File Number: 9-H-25-IH

Meeting: 9/17/2025
Applicant: Eric Forrestall Bald Design Services
Owner: Osuma Homes LLC
District: Lonsdale Infill Housing Overlay District

Location: 0 Ohio Ave. **Parcel ID:** 81 | C 029
Zoning: RN-2 (Single-Family Residential Neighborhood)
Description: New four-unit townhouse and site plan revisions to 6-C-25-IH

Comments

**SIDE
ELEVATIONS**

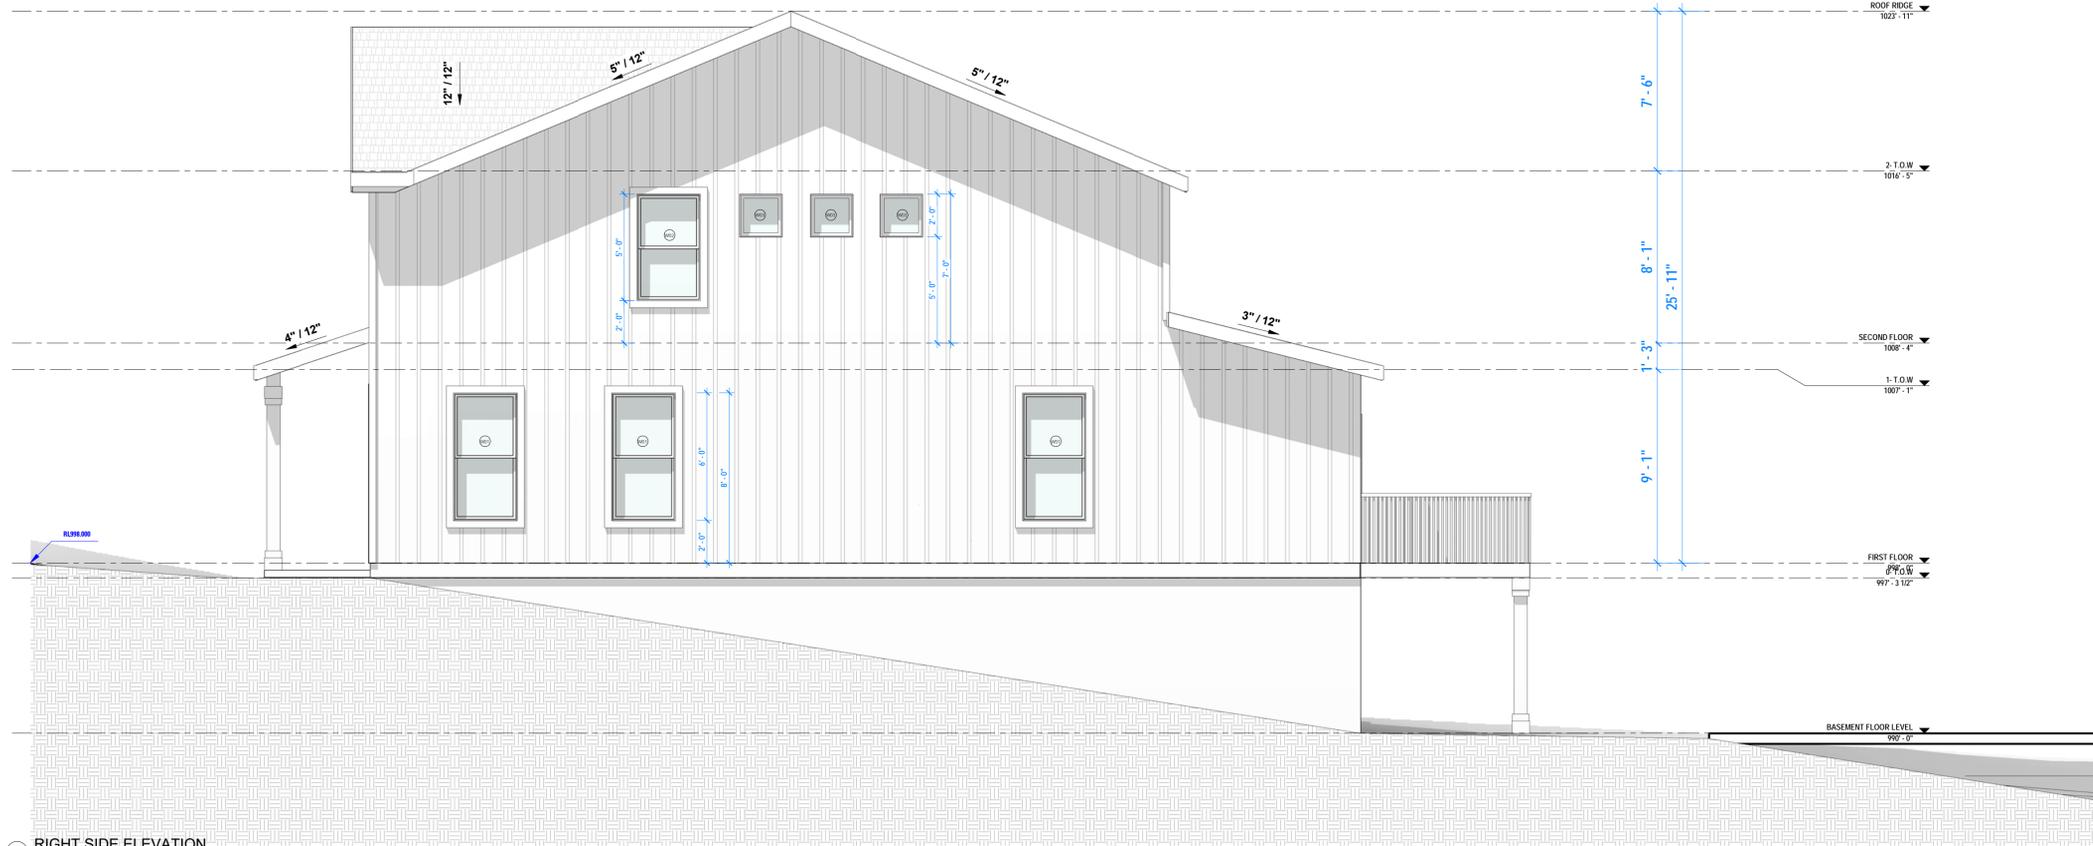
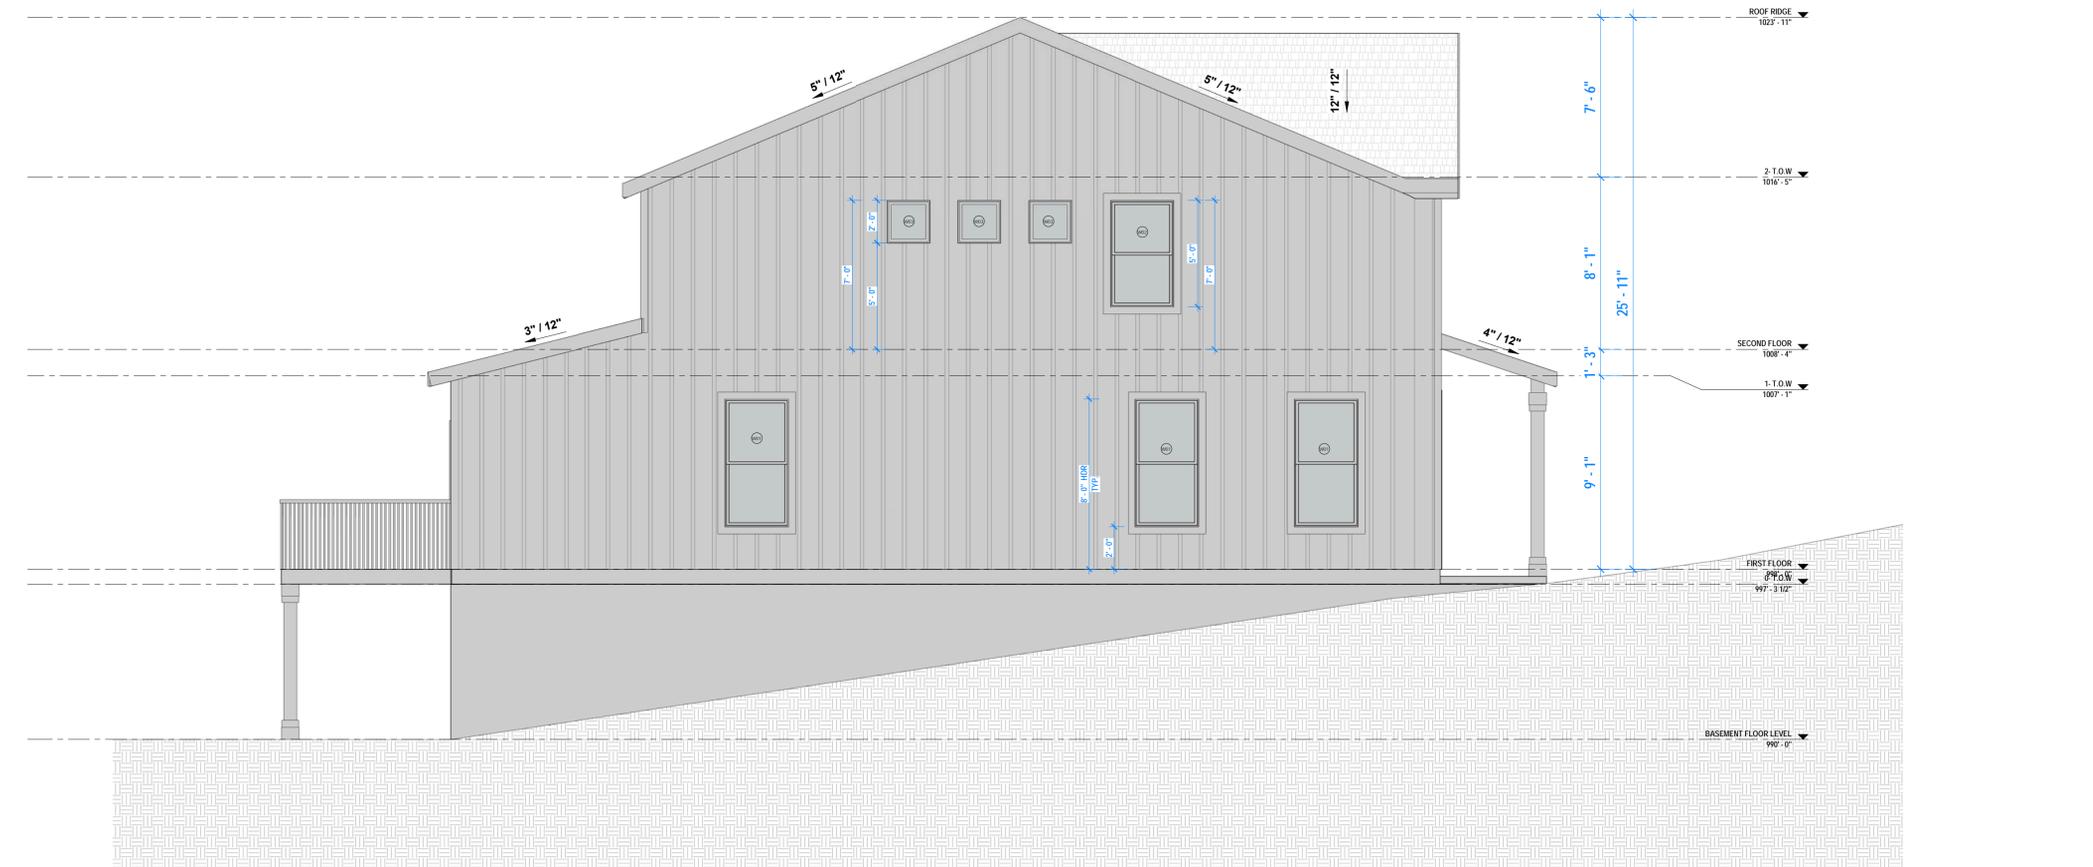
10. Guidelines recommend that windows and door styles be similar to historic houses on the block, with similar proportions and positioning, and similar ratio of solid to void. The proposed single-hung windows and half-light paneled door are compatible with the context. The location of the single-hung window on the second story, side elevations should be aligned above the window on the first story. The slider windows on the rear elevation and small fixed windows on the side elevations are not compatible with historic window forms; revisions should be made to the side elevation window patterns to address the three fixed windows.

12. The asphalt shingles meet design guidelines. The applicant should clarify the proposed foundation material; if it is concrete block or slab, it should be parge-coated, clad in stucco, or clad in brick veneer. Design guidelines discourage the use of vertical siding, and board-and-batten siding can be used as an accent material only. The Board approved horizontal siding as the primary siding material on 6-C-25-IH, except to allow siding variation on the side elevations with horizontal siding at the base.

Staff recommends approval of Certificate 9-H-25-IH, subject to the following conditions: 1) meeting all relevant standards of Article 4.6 and Article 9.3.I, with minor revisions to be approved by staff; 2) revisions to the front setback to meet Article 4.6; 3) revisions to side elevation window design and placement, to be approved by staff; 4) roof pitch to be revised to at least 6/12; 5) siding to be clapboard-style with an overlap, with board-and-batten used as an accent and to allow siding variation on the side elevations with horizontal siding as the base; 6) the final site plan to retain the existing trees as much as possible, including at least one tree in the front and rear yard of both townhouse buildings; 7) approval of the site plan option featuring the shared driveway, with final site plan meeting City Engineering standards and any major deviations to the approved site plans and plat (6-C-25-IH), including the closure of the Ambrose Street right-of-way, to return the Board for review; 8) the foundation to be parge-coated, clad in stucco, or clad in brick veneer; 9) the porch posts to be at least 8" by 8"; and 10) incorporating differentiation between the two adjacent townhouse buildings, to be approved by staff.

1 ROOF PLAN
1/4" = 1'-0"

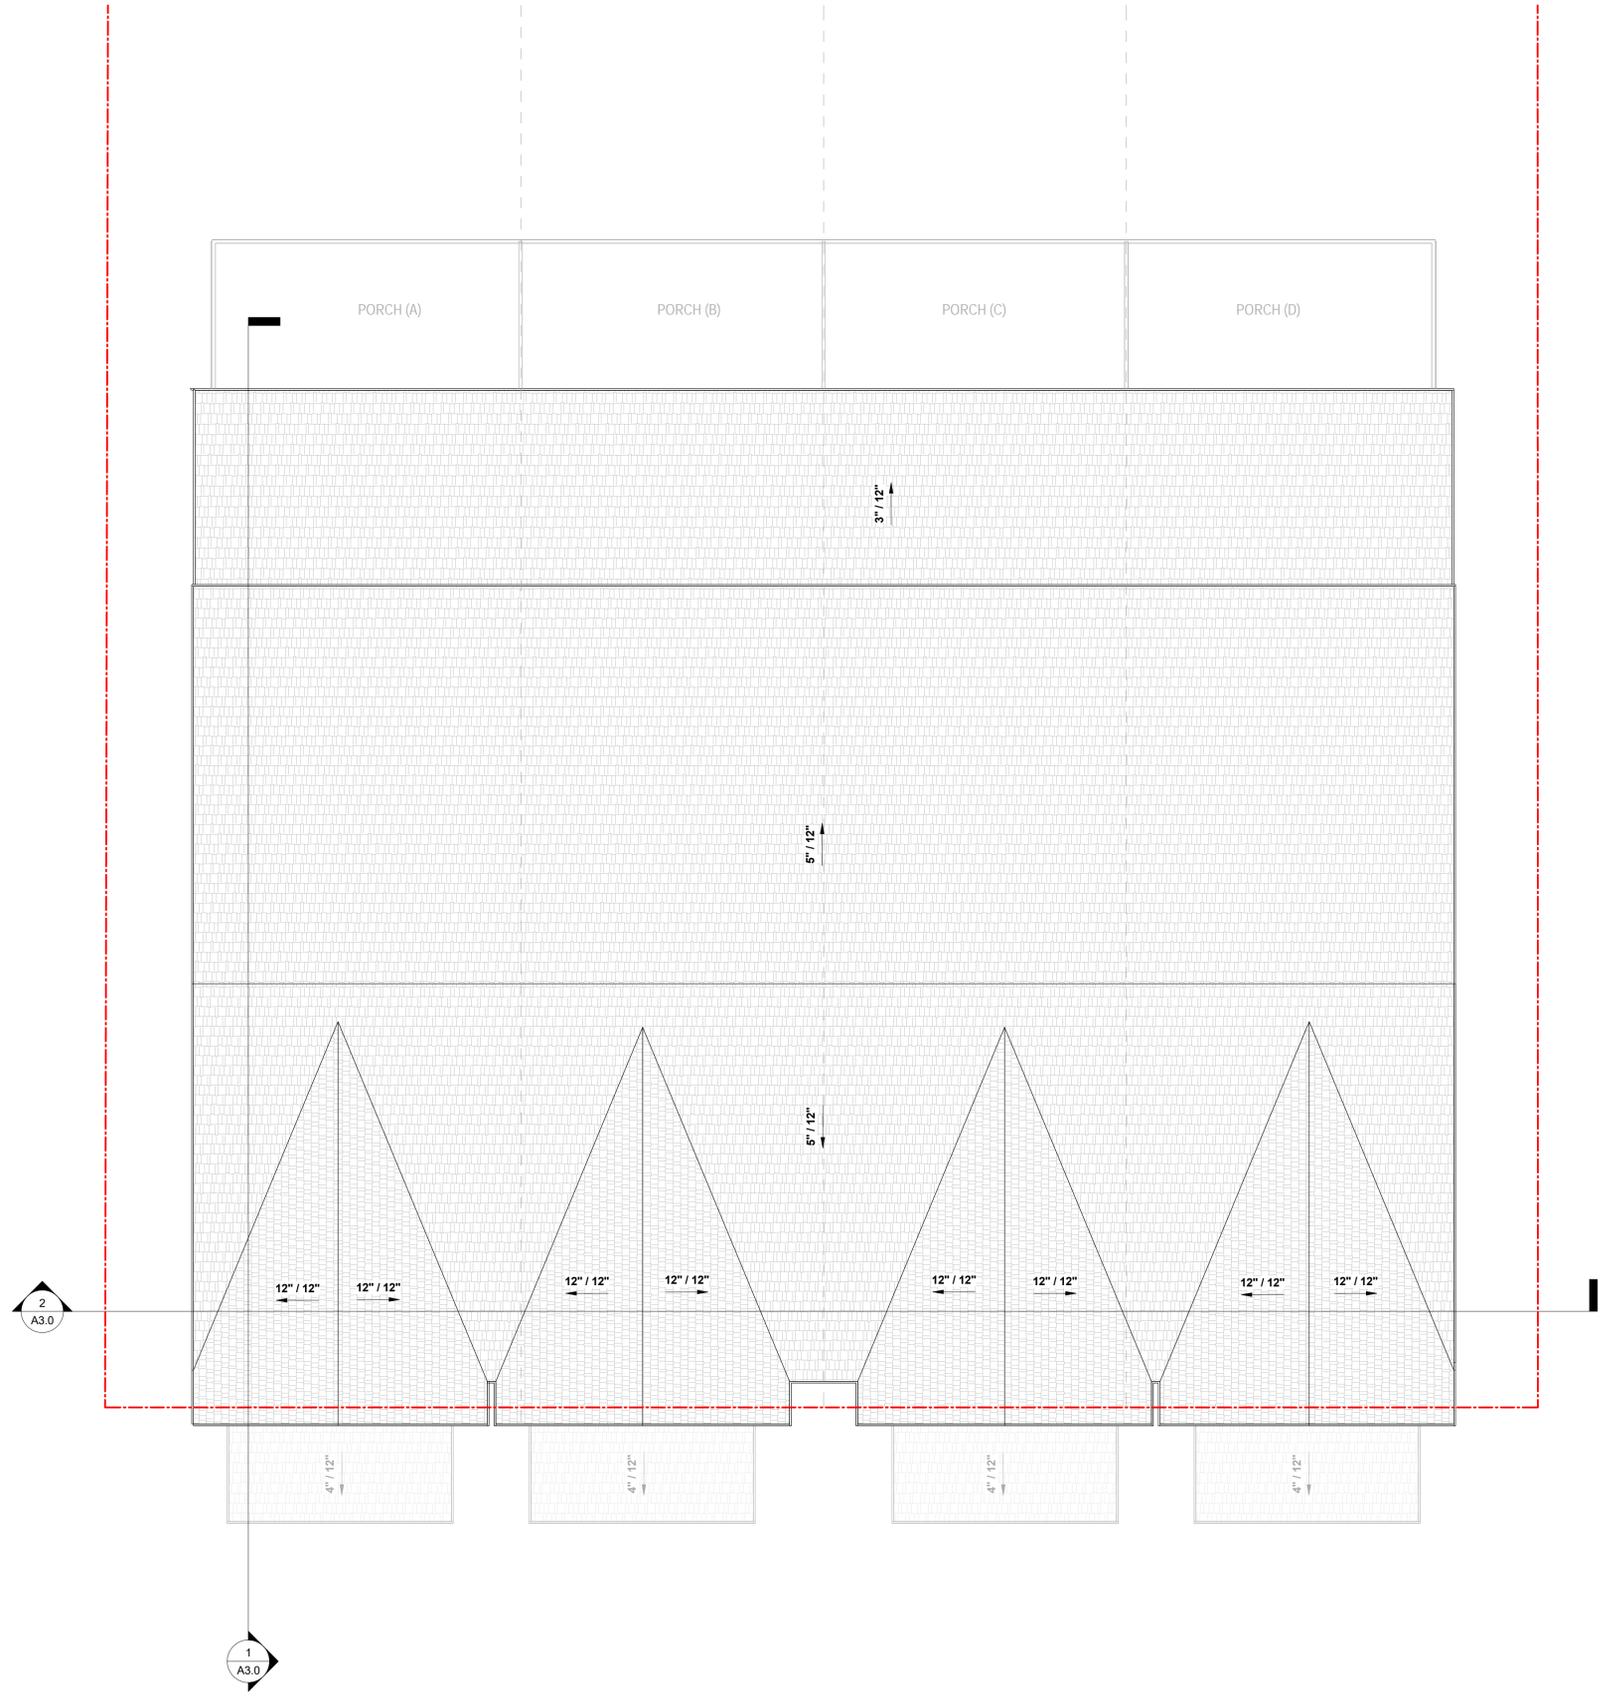
11. At least a 6/12 roof pitch is required in the Middle Housing standards to fulfill the "steep" category of roofline; 6/12 is also the minimum pitch recommended by the DRB. The roof pitch should be increased to at least 6/12.
